то:	CHAIR AND MEMBERS PLANNING & ENVIRONMENT COMMITTEE
FROM:	JOHN M. FLEMING MANAGING DIRECTOR, PLANNING AND CITY PLANNER
SUBJECT:	APPLICATION BY: YORK DEVELOPMENTS (LONDON) INC. 1192 HIGHBURY AVENUE NORTH PUBLIC PARTICIPATION MEETING ON JUNE 15, 2015

File: OZ-8463

The purpose and effect of this Official Plan and zoning change is to permit a commercial development proposal for two restaurants with drive-throughs.

Conceptual site plan for the proposed development

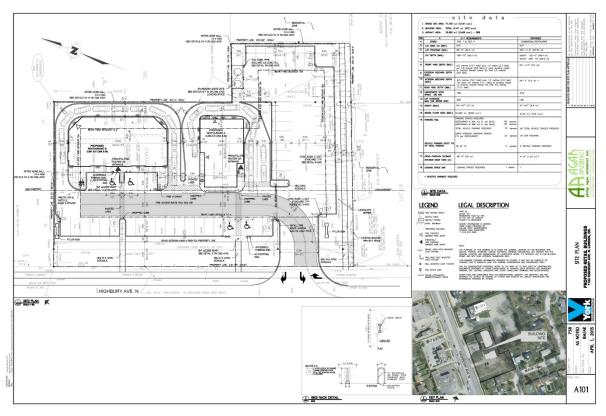
- Due to a required Union Gas setback, the buildings are not able to be located closer to the public right-of-way. The applicant is commended for locating the drive-thru facilities to the rear of the buildings.

- Widen, and straighten as much as possible, the primary pedestrian walkway coming from Highbury Ave. This entrance should be enhanced with landscape and/or built components to frame it at the street edge, as well as decorative pavement treatment where it crosses the vehicular drive aisle. Decorative pavement treatment should also be used for the crossing through the drive-thru aisles.

- Depending on the use there is insufficient stacking for a donut shop and/or a fast food restaurant.
- Placement of a pylon sign does not guarantee nor does it actually have any effect on which entrance is used (typically the first entrance drivers see they use)
- The current centre lane rumble strip is consistently used by drivers making left turns and does not act as a deterrent (only a physical barrier would accomplish this)
- The northerly proposed access is not supported overlap with Tim Hortons entrance
- The need for two access is not supported (one access with one inbound lane and an outbound left & right lane would be more appropriate)
- A left turn lane should be provided into the site

- The proposed drive thru lanes were modified on the revised site plan to accommodate stacking for up to 12 vehicles.
- [The placement of a pylon sign] is not applicable anymore since now there is one entrance only.
- Transportation agrees to the recommendation in the revised TIA for the section of rumble strip located between the proposed entrance to the subject site and the existing Tim Horton's entrance to be replaced with a two-way left turn lane.
- The north access has been removed leaving one entrance only located near the south limit of the site.
- [The revised conceptual site plan depicts one vehicular access]
- A left turn lane should be provided into the site as noted above.
- Transportation staff has reviewed the revised TIA and have no further comments

- 2.2 Ensure pedestrian connections into the site at both the north and south ends.
- 2.3 Ensure a continuous and well-defined pedestrian system throughout the site, especially in front of the south building.
- 2.4 Minimize curb radii where possible.

- 4.1 The ornamental grass specified on both sides of the public walkway on the south side of the site will result in an inappropriate tunnel effect. It's recommended that a shorter species of grass be specified for the north side of the pathway to ensure visibility for pedestrians.
- 4.2 The extent of frontage would allow for a staggered double row of street trees (high canopy for visibility of the buildings). That coupled with shrubs would effectively screen the proposed parking.
